CONCRETE OUTLINES		
REVISION	1	REVISION DESCRIPTION
DATE	03/13/2000	SUBMITTAL FOR APPROVAL

ESSENTIAL SERVICES PARKING GARAGE  
STOCKTON, CA

McCLONE CONSTRUCTION JOB #405

DISTRIBUTED ON 03/13/00 AS
<input checked="" type="checkbox"/> SUBMITTAL FOR APPROVAL
<input type="checkbox"/> PRELIMINARY INFORMATION
<input type="checkbox"/> REVISION NO. <span style="border: 1px solid black; padding: 0 5px;">1</span>
<input type="checkbox"/> OTHER
BY:
DATE:
DRAWING INDEX
ESSENTIAL SERVICES PARKING GARAGE STOCKTON, CA
McCLONE CONSTRUCTION COMPANY 4340 PRODUCT DRIVE • SINGLE SPRINGS, CA 95687 VOICE (530) 677-1027 • FAX (530) 677-3984
SCALE 1/4"=1'-0"
DOWN BY CSW
JOB 405
SHEET INDEX

<b>2ND FLOOR</b>	
ESSENTIAL SERVICES PARKING GARAGE	CALIF STOCKTON
Date 4-4-2000	Scale 1/8" = 1'-0"
Drawn 15	Job 451
Sheet PT-5	Of Sheets

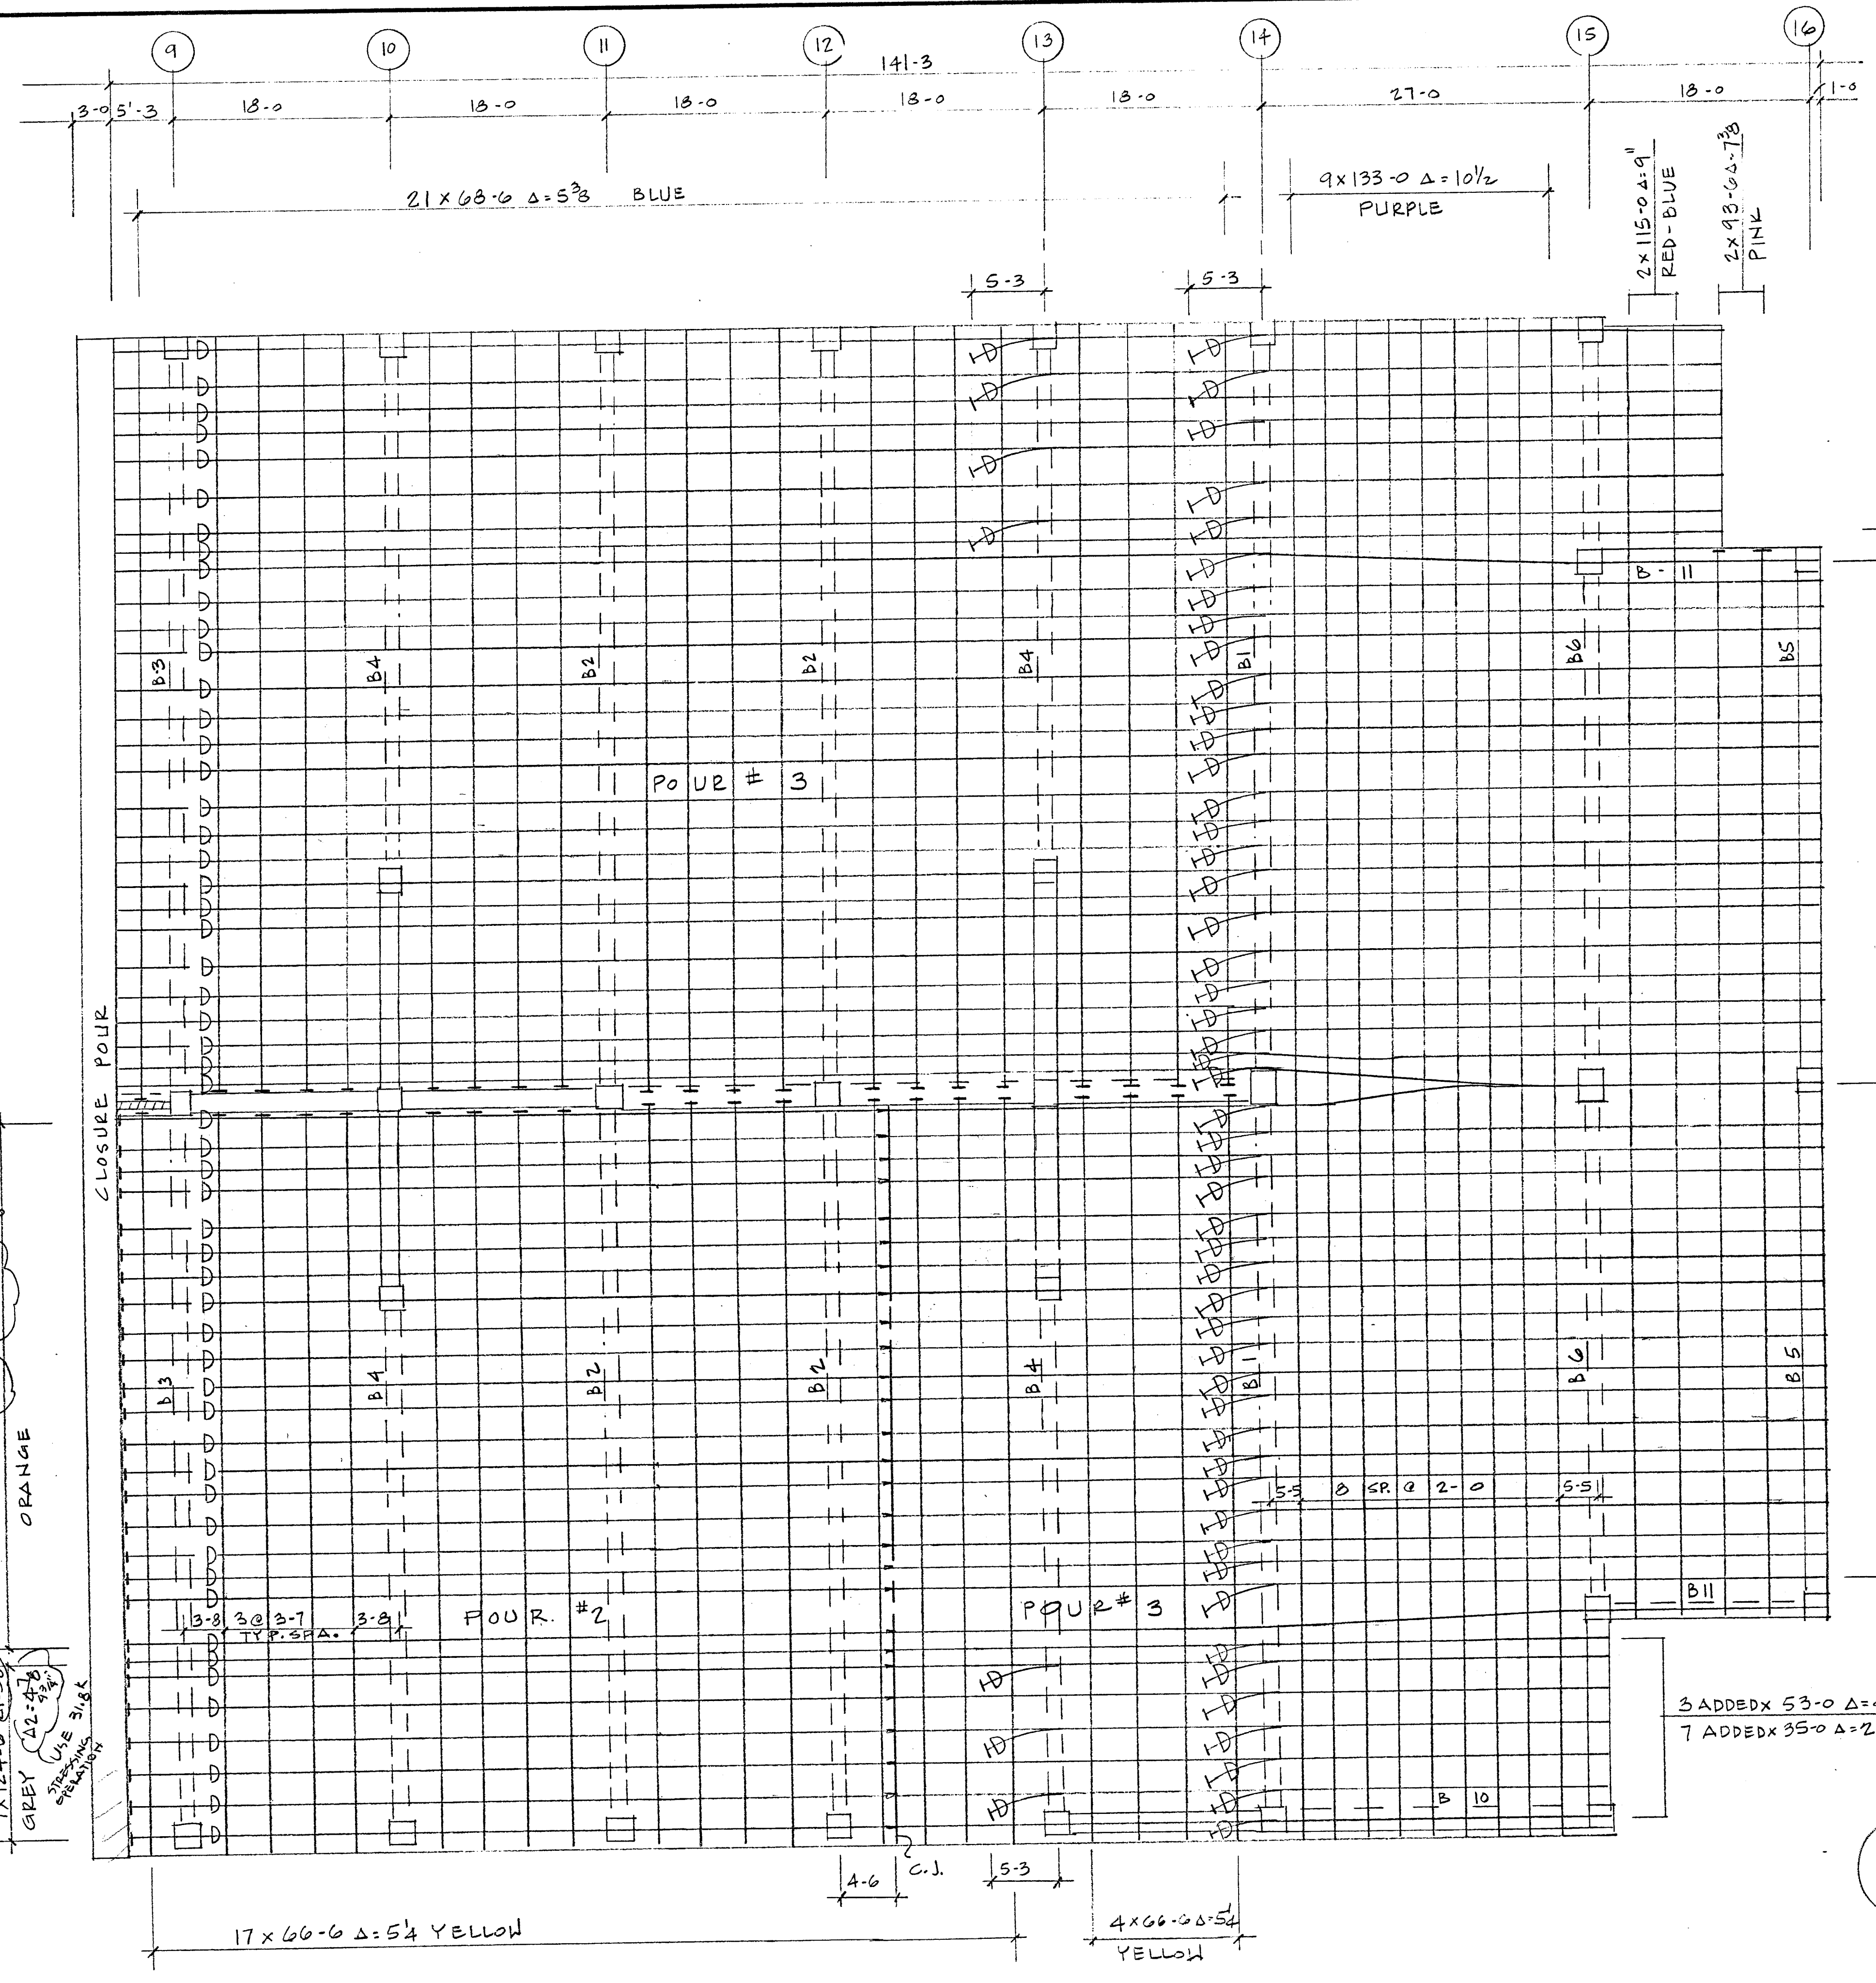
*provide jack calibration chart w/ max jacking force, lift-off force and req'd elongation for test lab to verify procedure*

**PARTIAL GROUND FLOOR PLAN**  
1/8" = 1'-0"

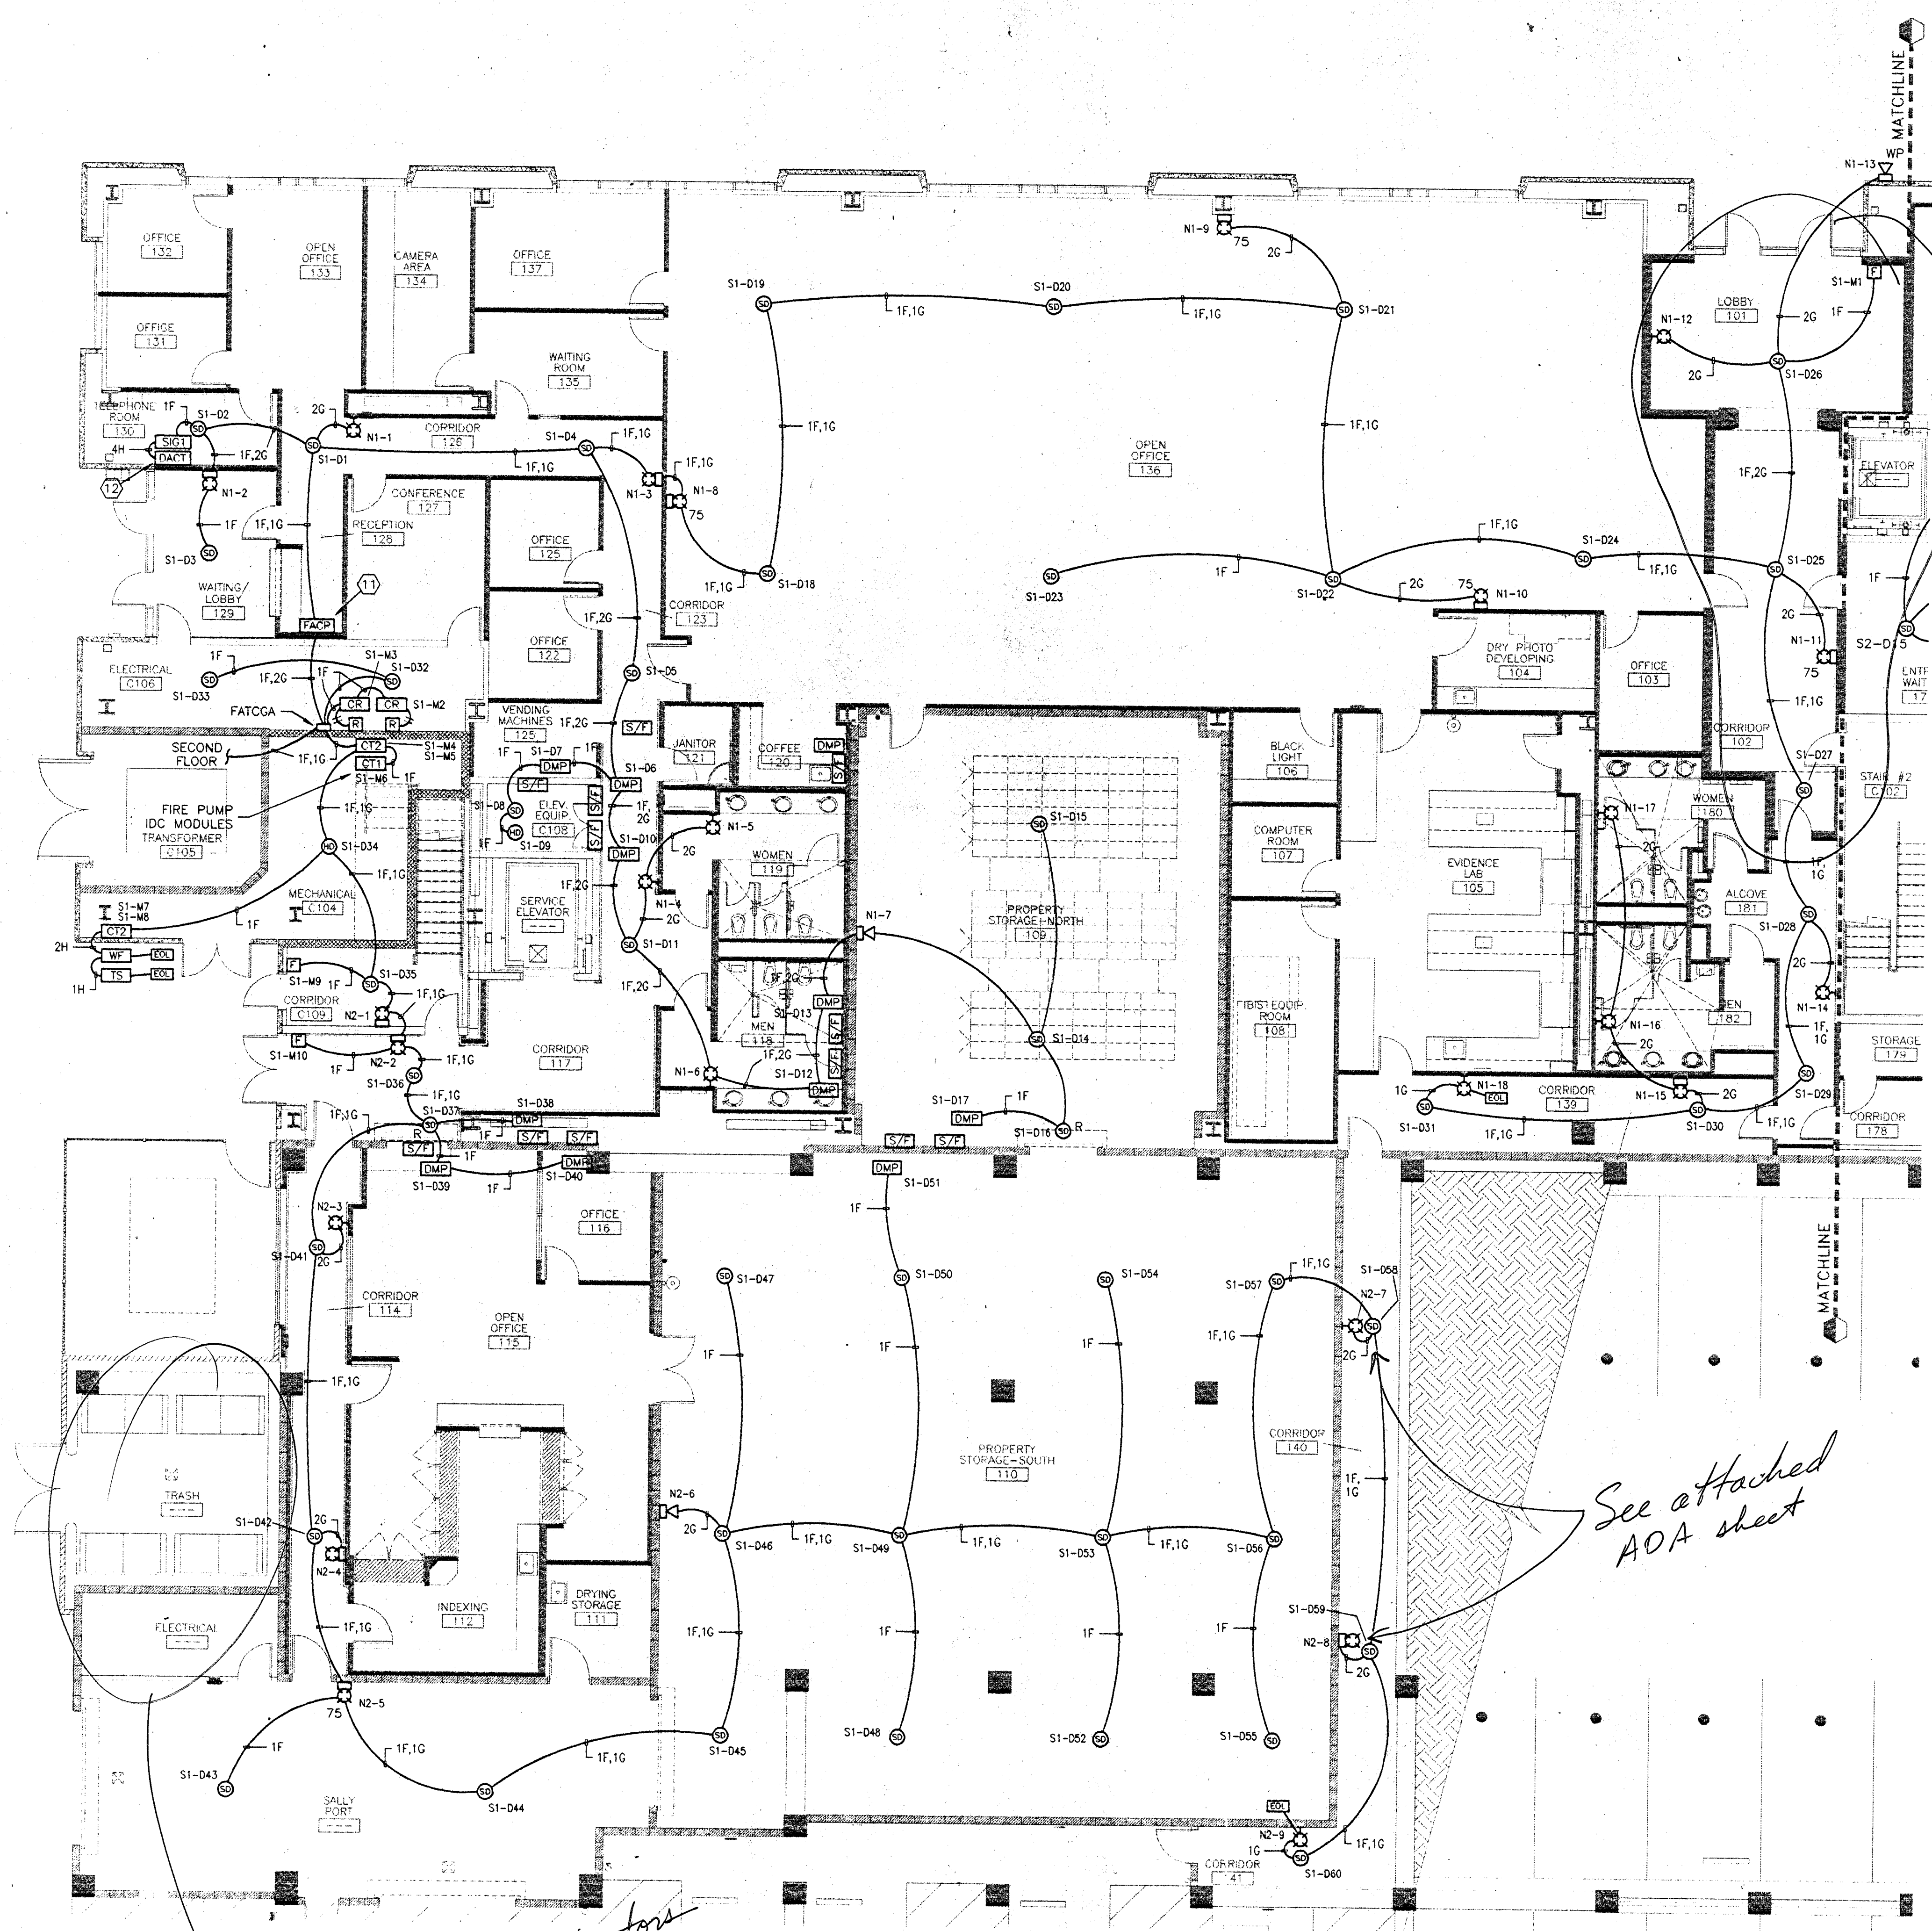
*Coordinate layouts of sheet A4.03*

*See attached AOA sheet*

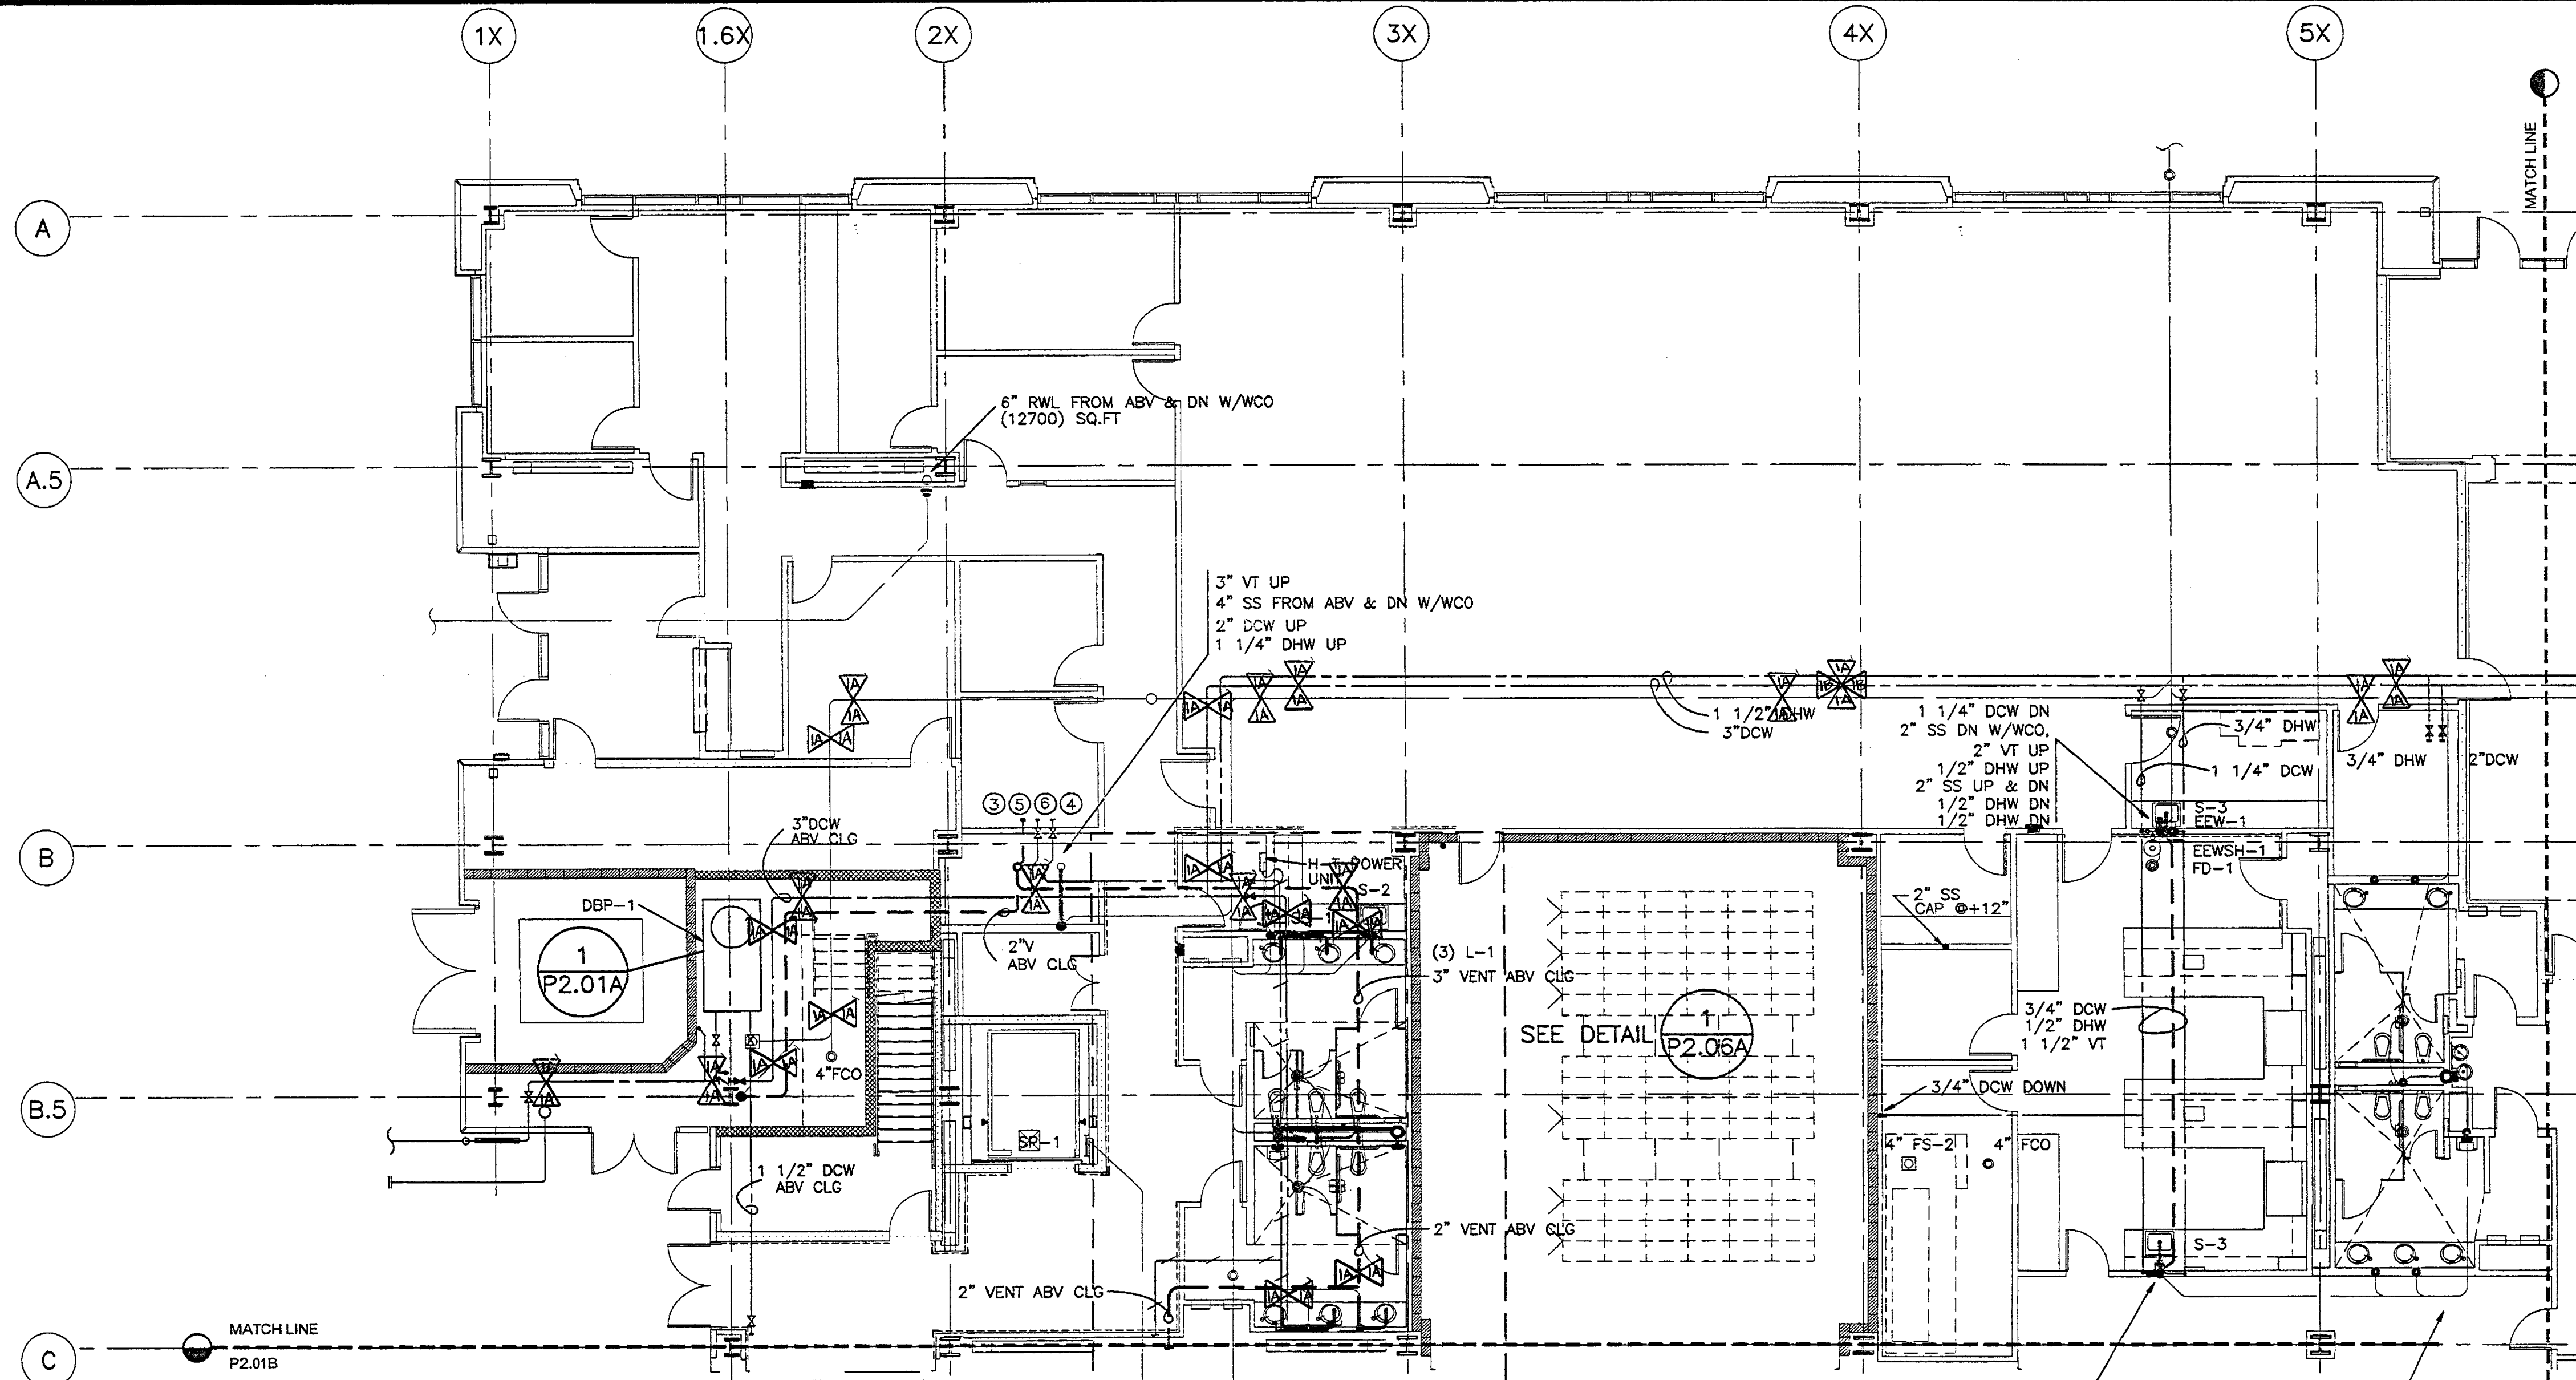
*Deferred to Struct. review*
